Model: 500/650/750 Ton TDs

Feb. 6, 2020

Product Bulletin # TDS-213 v 1.0

Top Drive Limit Switch Guard

Figure 1: Limit switch guard location

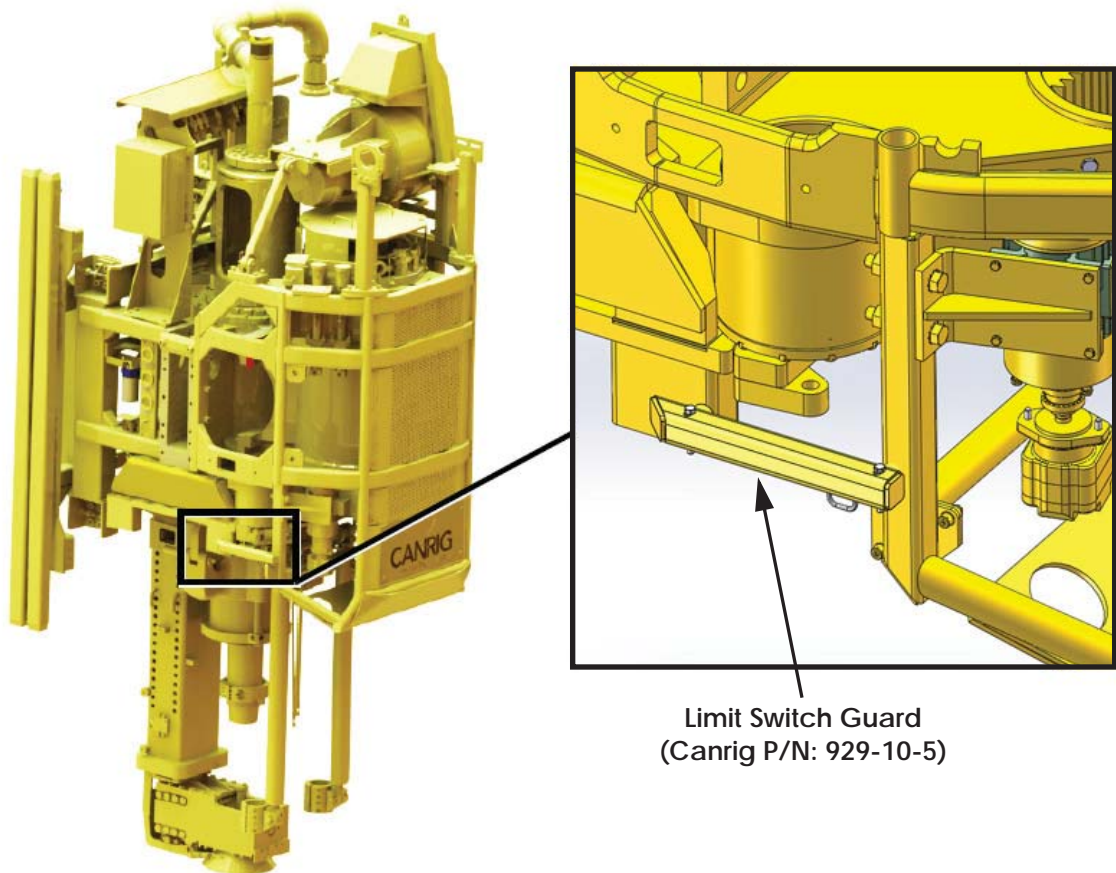
Incorrect installation of the top drive limit switch guard (Canrig P/N: 929-10-5) creates a risk that a winch cable will snag (see Figure 2 on page 2) on the limit switch guard while using hoisting lines.

3. If the unmodified limit switch guard Canrig P/N: 929-10-5 is installed (refer to Figure 1 on page 1 and Figure 2 on page 2), modify the limit switch guard per following instruction.

Figure 2: Winch line stuck in limit switch guard (Canrig P/N: 929-10-5)

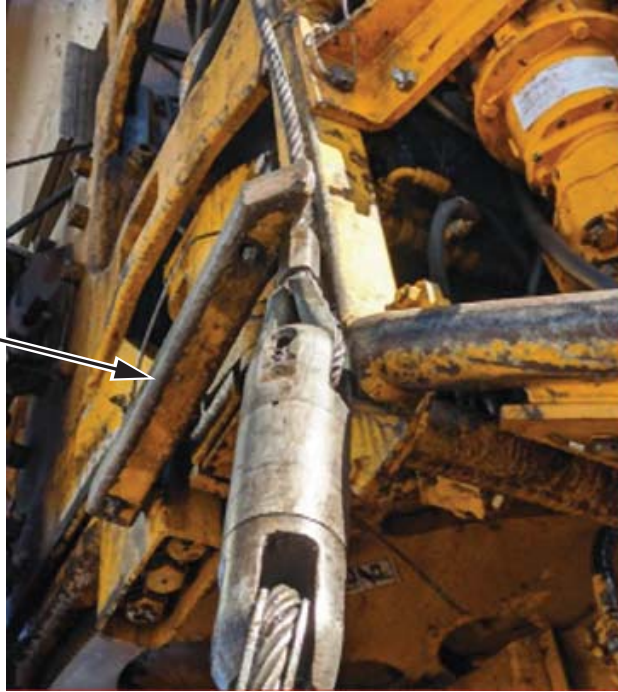
Limit Switch Guard
(Canrig P/N: 929-10-5)
was installed incorrectly

Figure 3: Limit switch guard (Canrig P/N: DT22459)

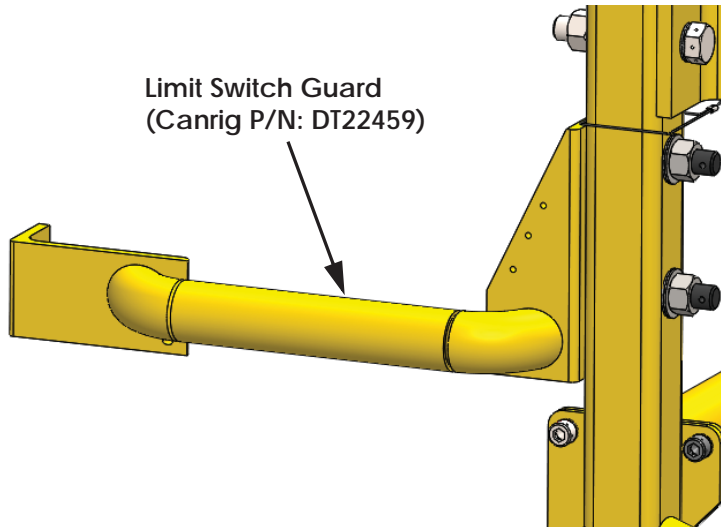
1. Visually inspect the limit switch guard on top drive to identify which limit switch guard is installed. Verify the fasteners are properly torqued and safety securement is installed.
2. No further action is required if:
 - 2a. Limit switch guard Canrig P/N: DT22459 is correctly installed (refer to Figure 3 on page 2).
 - 2b. Limit switch guard Canrig P/N: 929-10-5 is installed and was modified per Canrig Product Alert TDS-150 (released on July 28, 2015).
 - 2c. Limit switch guard was correctly replaced with modified design Canrig P/N: DT22650 (refer to Figure 4 above).

Figure 6: Modified limit switch guard Canrig P/N: DT22650

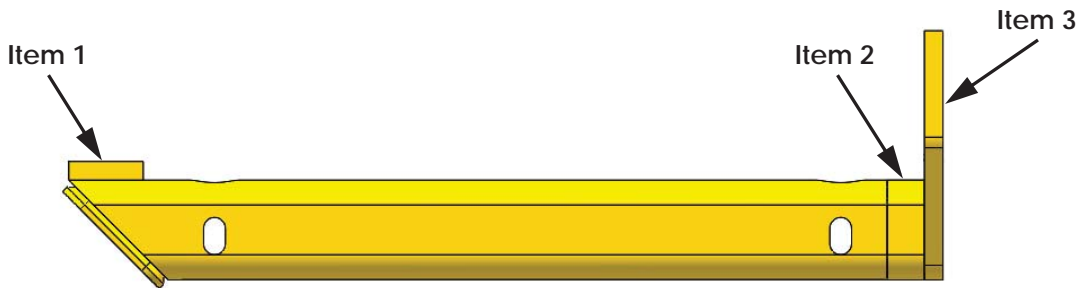
Instruction to Modify the Limit Switch Guard P/N: 929-10-5 into Canrig P/N: DT22650

Figure 7: Details for item 1 and item 3

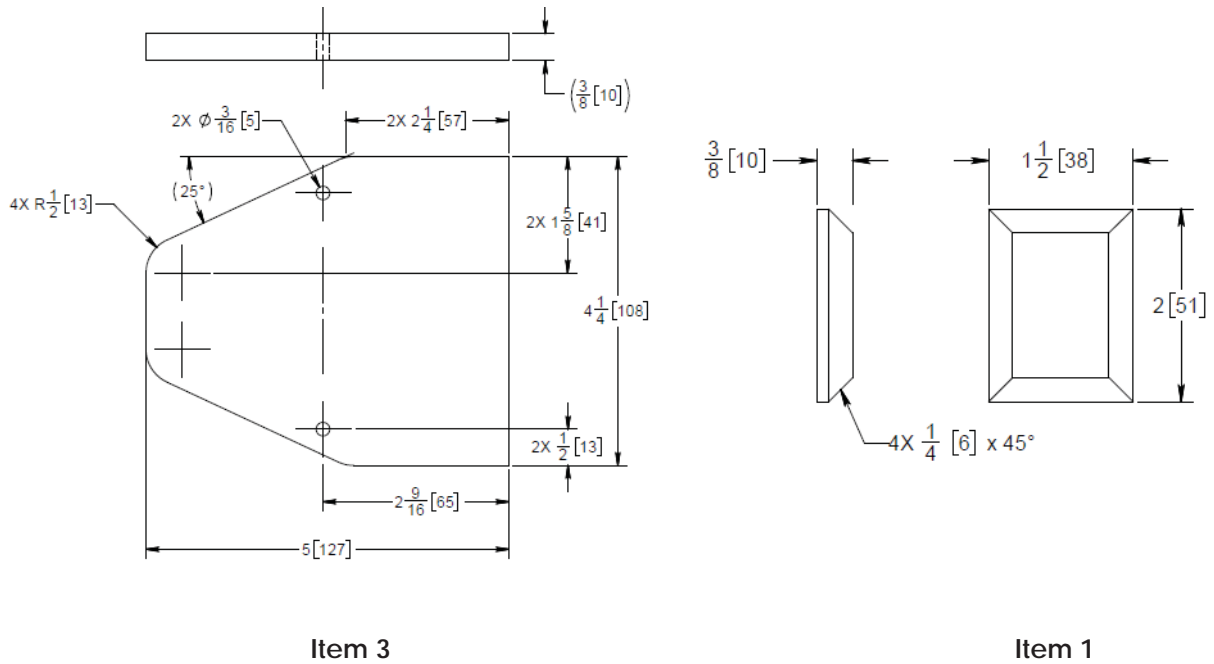
1. Refer to Figure 7 for details of item 1 and item 3.
 - 1a. Cut the HSS (Item 2, 2 X 2 X ¼") to the appropriate length so the top plate (Item 3) sits flush on the HSS of the top drive guard as shown in Figure 10 on page 7.

Figure 9: Fabrication details

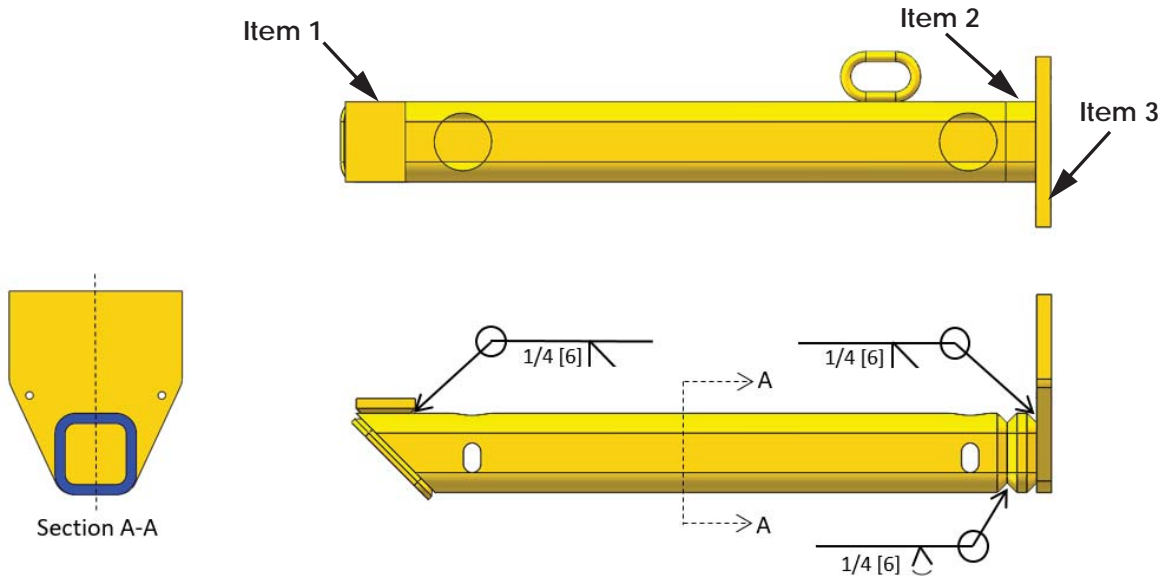
- Use a low hydrogen welding rod E7018 to weld the spacer (Item 1), HSS (Item 2) and top plate (Item 3) to the limit switch guard as shown in Figure 9. Allow weld to slowly cool to ambient temperature using thermal blanket. Do not quench the weld.

- Perform a MPI (Magnetic Particle Inspection) to verify no cracks are present and then paint to prevent corrosion.

Figure 10: Modified limit switch guard securement

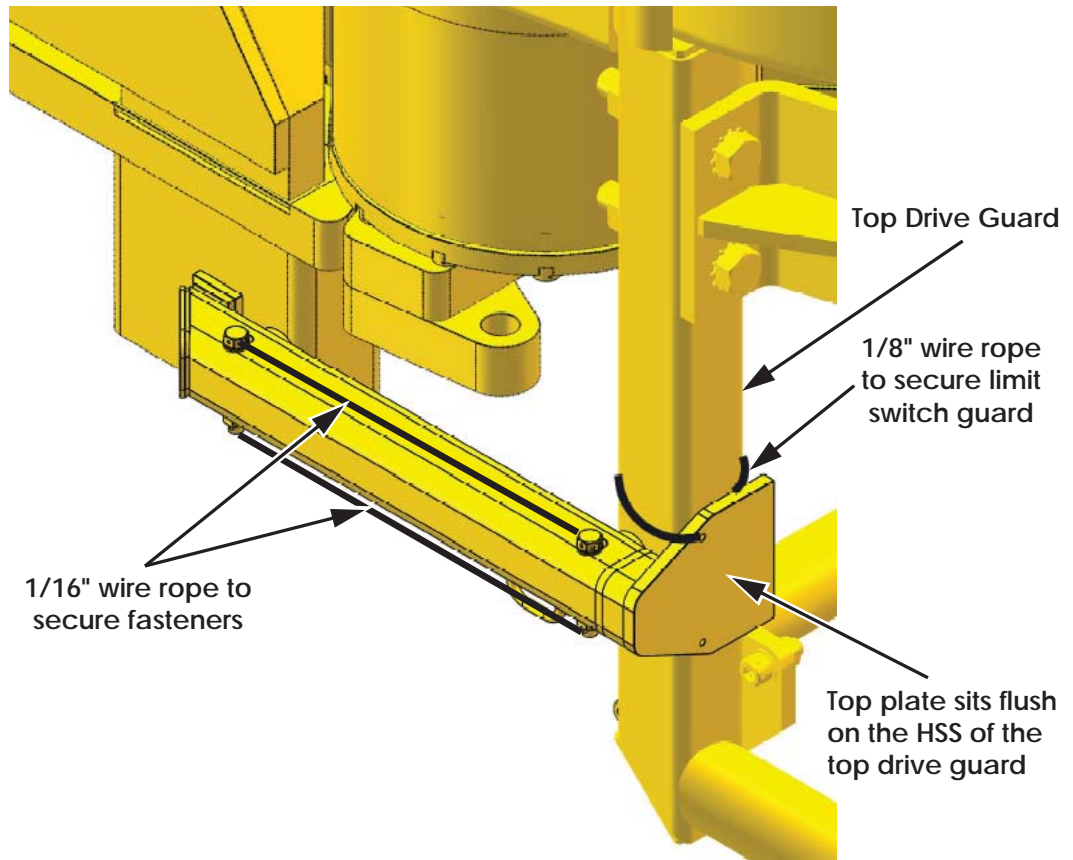
6. Mount the modified limit switch guard with the new fasteners (Grade 8 – 3/8" Hex head Capscrews 2 3/4" Long, 3/8" Lock Nut and Nord-Lock Washers). Use 1/16" wire rope to secure the fasteners. Use 1/8" wire rope to secure modified limit switch guard with top drive as shown in Figure 10.

Figure 1: Top Drive Limit Switch Guard Location

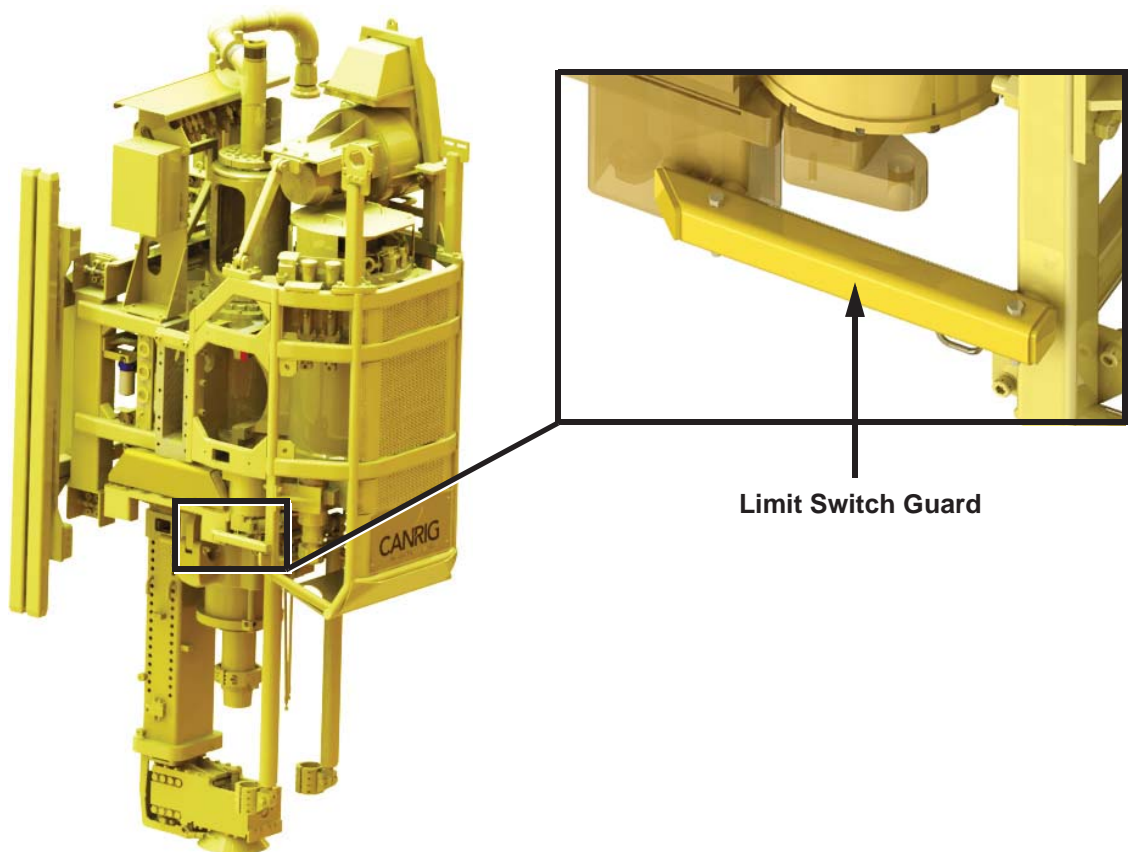
Care should always be taken when using lifting or winch cables around the top drive. There should always be someone monitoring the top drive to ensure nothing gets hooked or snagged. There are two gaps between the limit switch guard and the main guard assembly, located on the 500/650/750 ton top drive guard assemblies. Without proper monitoring, cables could inadvertently get in-between the components and potentially dislodge the limit switch guard and cause it to fall.

Figure 3: Limit Switch Guard with Plates

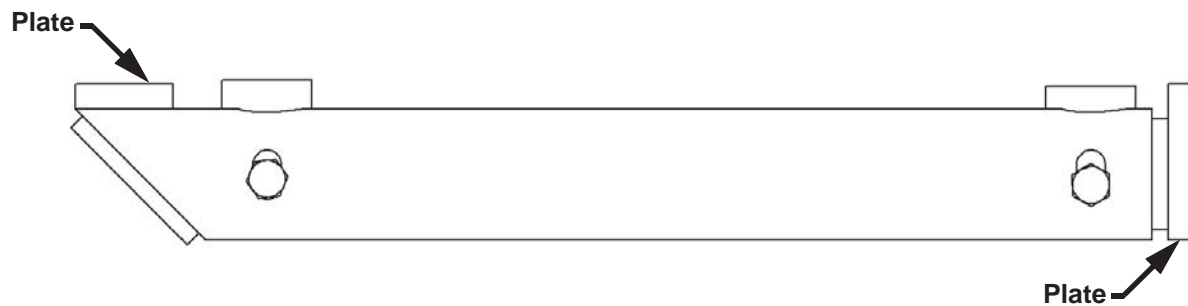
2. To minimize the risk of getting a line behind the guard, a plate/bar can be welded to the limit switch guard as shown in Figure 3. Remove limit switch guard before welding on the two plates/bars. Weld the plate/bar as per Canrig specification ENG 704.

Figure 4: Top View

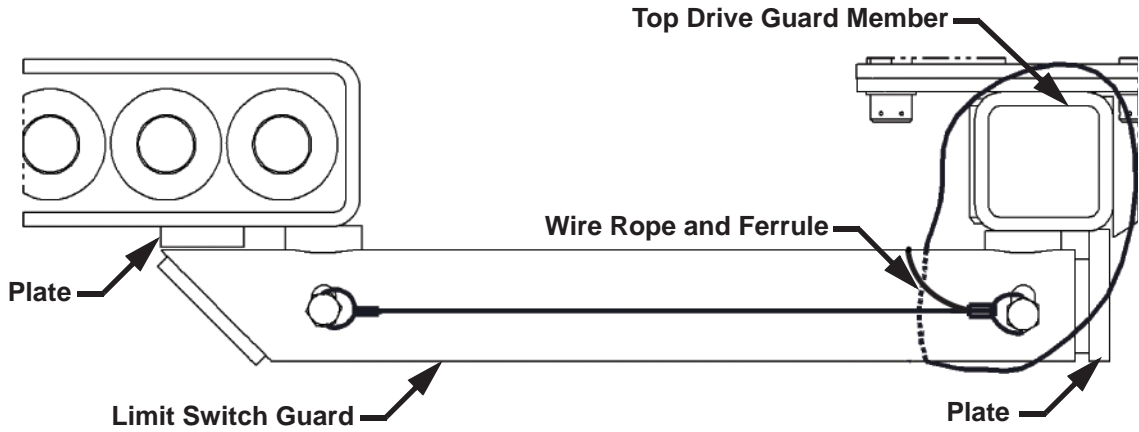
3. Ensure the bolt heads are drilled for safety wire. Replace if necessary with 3/8" UNC X 2 3/4" LG Hex Head Cap Screw, Grade 8.
 - Route safety wire from one limit switch guard bolt head to the other one and then route the wire to connect to the existing chain link. See Figure 4 and Figure 5 on page 3.
 - To secure the bolt ends, drill a 1/8" hole at the bolt end and route safety wire from the end of each bolt to the existing chain link. See Figure 5 on page 3.
 - Use 1/16" safety wire and ferrules as per Canrig specification ENG 701.

4. Route safety wire around the top drive guard member and through the chain link as shown in Figure 4 and Figure 5.
 - Use 1/8" safety wire and ferrules as per Canrig specification ENG 701.
